Re: McDade-Woodcock Building, 2402 Claremont NE,

Approval of Permanent Certificate of Occupancy (C.O.)

RE: McDade-Woodcock Building, 2402 Claremont NE (MAP H16-D 142) "Rev. 1"- Grading & Drainage Plan for Building Permit & SO-19 - PE Stamp 03-27-09

RE: McDade-Woodcock Building, 2402 Claremont NE (MAP H16- D 142) Grading & Drainage Plan for Site Plan & Building Permit (PE Stamp 12-19-08)

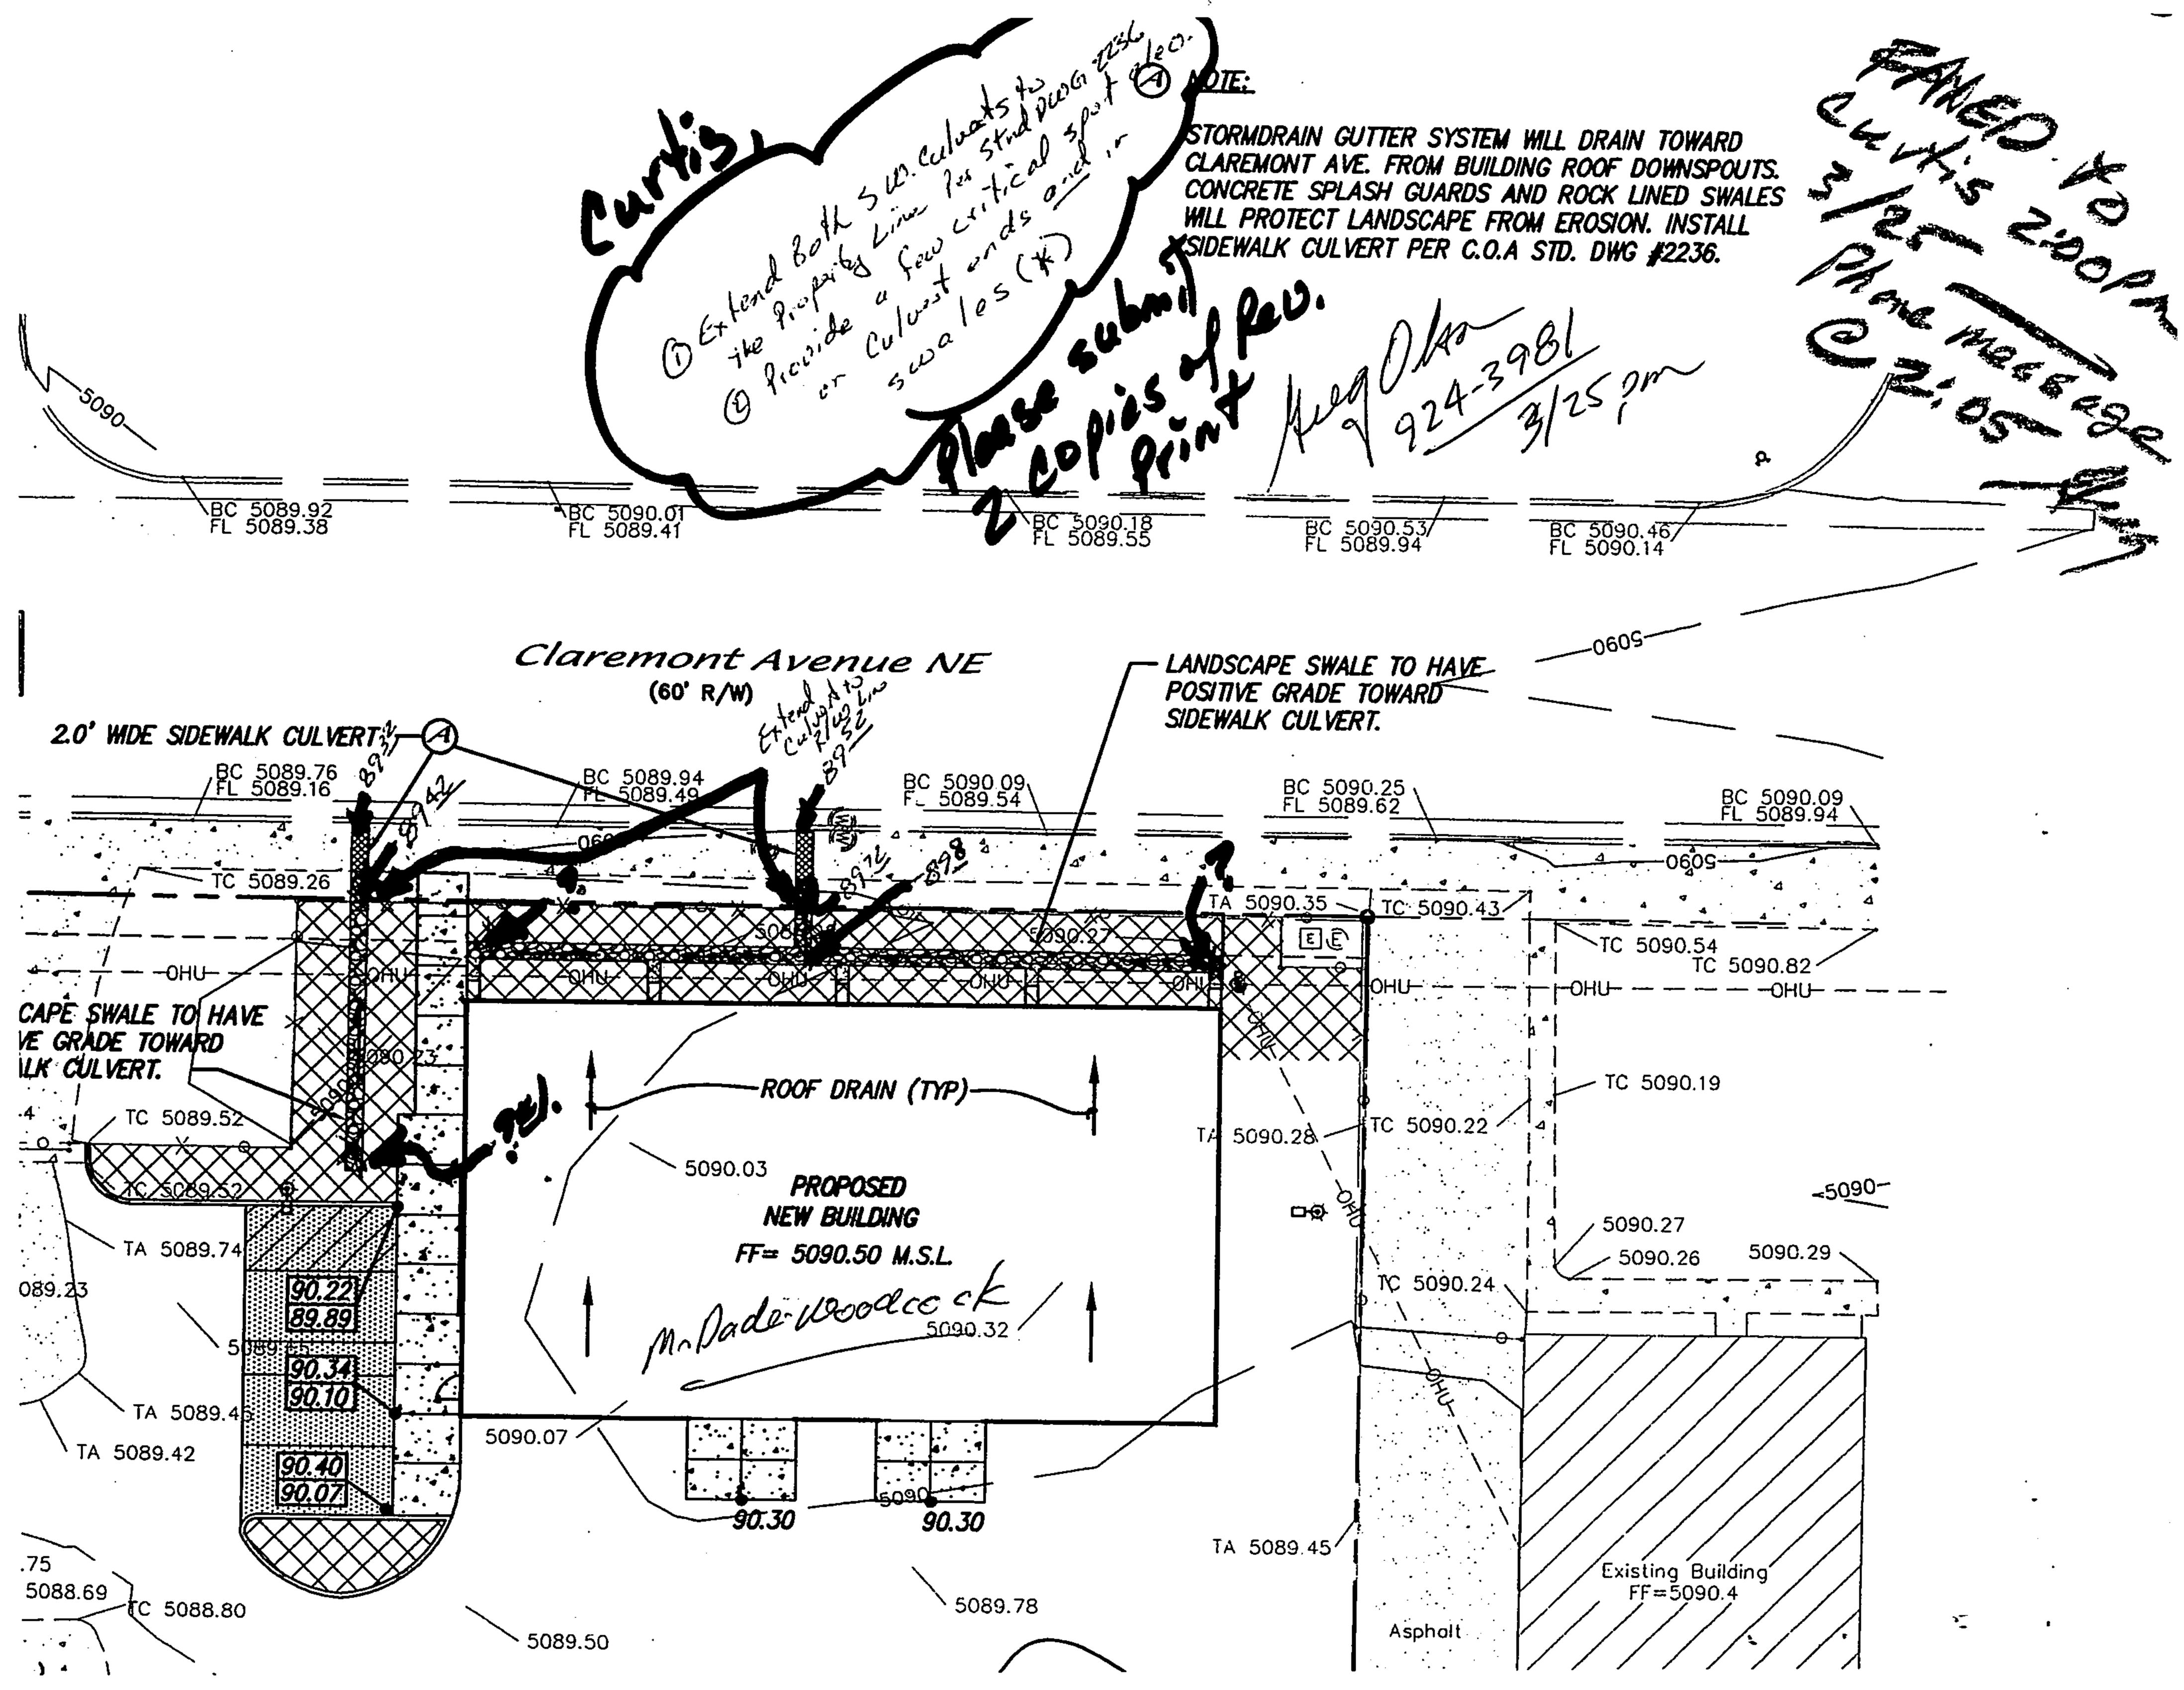
sidewalk cu submittal is This Grading and Drainage Plan had to make changes to the site affect concept in how the site will culverts the erts and adding grading and o adding d ain plan based of the land of the small plan. or its peak flows. parking area ne to the original approved plan. The zoning department requirements. he revision for the propo proposed to the site buildi plan se changes did not includes relocation Included relocating y with this with

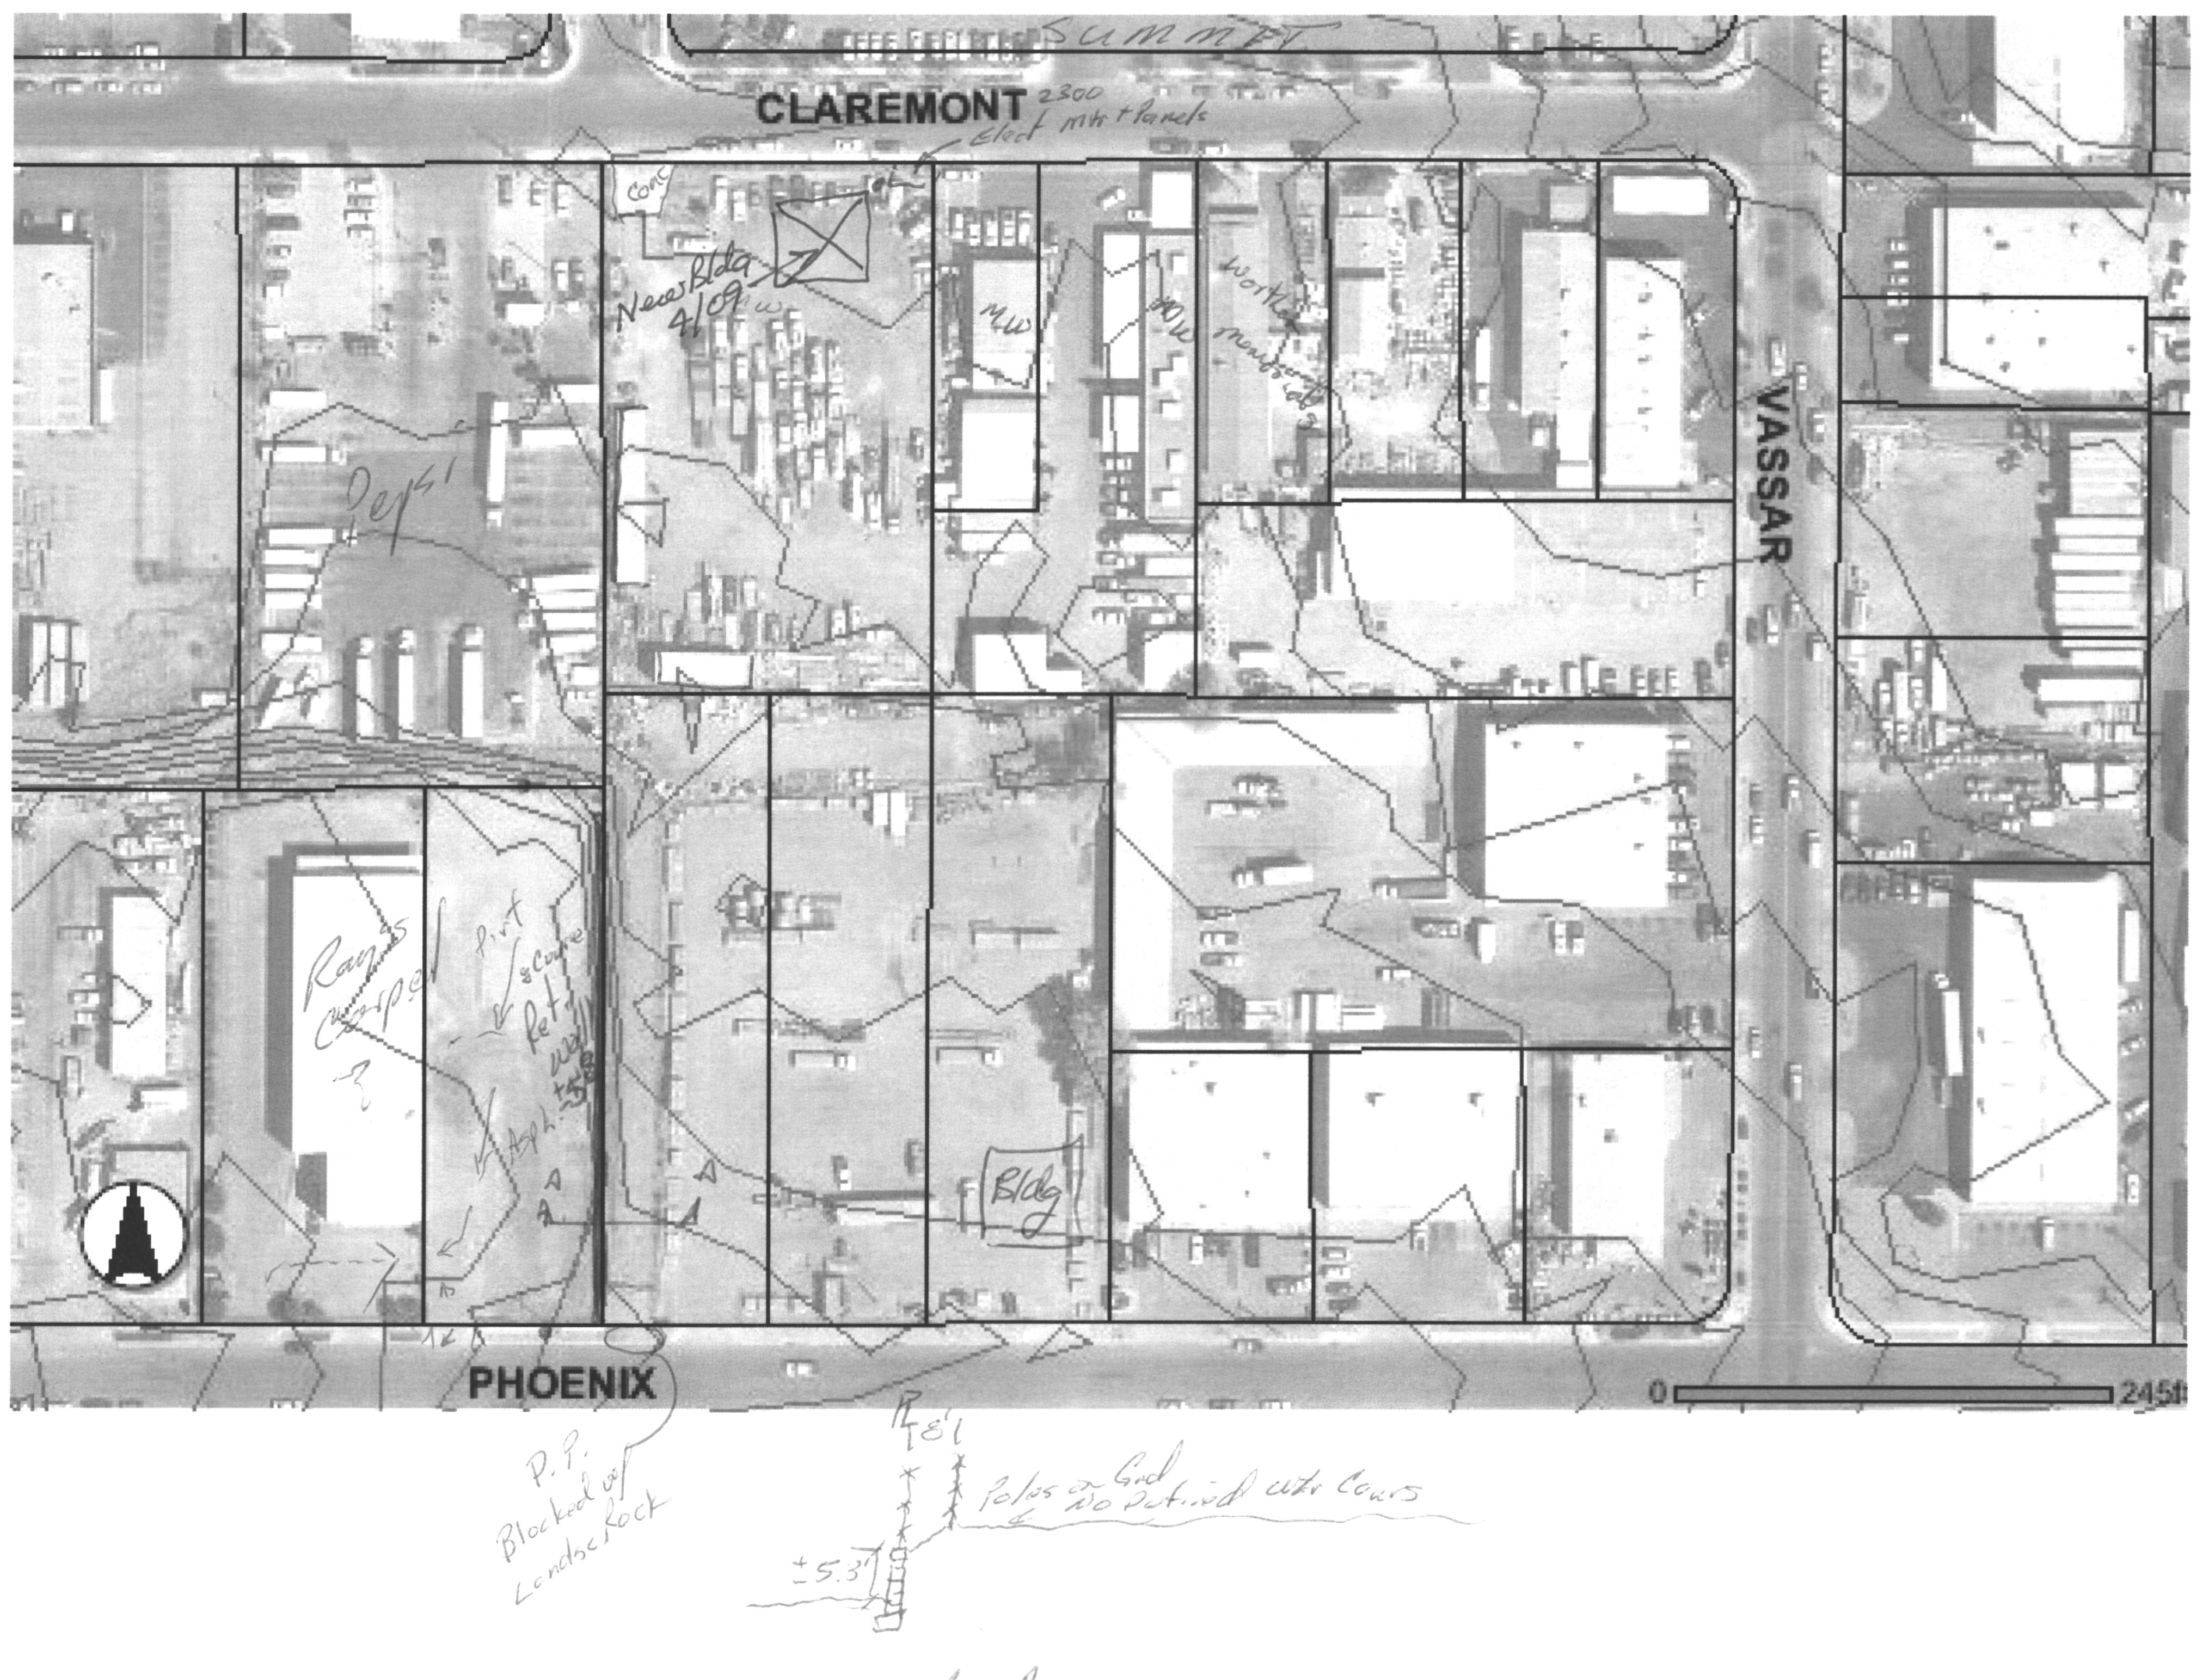
Based upon information in your submittal received 12/22/08, the above referenced Grading and Drainage Plan cannot be approved for Building Permit until the following issues are addressed:

- 1. Clarify on the maps and narrative that the street to the south, where site flows are draining, is Phoenix, not Princeton.
- 2. The Grading and Drainage Plan must reference the applicable FIRM map which indicates that no Flood Zone overlays the site.

- 3. Proposed improvements are increasing site discharge by more than 10%. Downstream conditions and possible improvements must be included in this plan to ensure that flows remain in established drainage ways and do not increase erosion.

- 4. If both this site and the downstream property are owned by the developer, it would be appropriate at this time to dedicate downstream drainage easement rights.

- 5. An alternative to dealing with downstream conditions would be to divert enough of the developed flows north to Claremont Street, and avoid increasing the flow rate to the private property south. (e.g.- Divert new building roof runoff through a sidewalk culvert on Claremont)
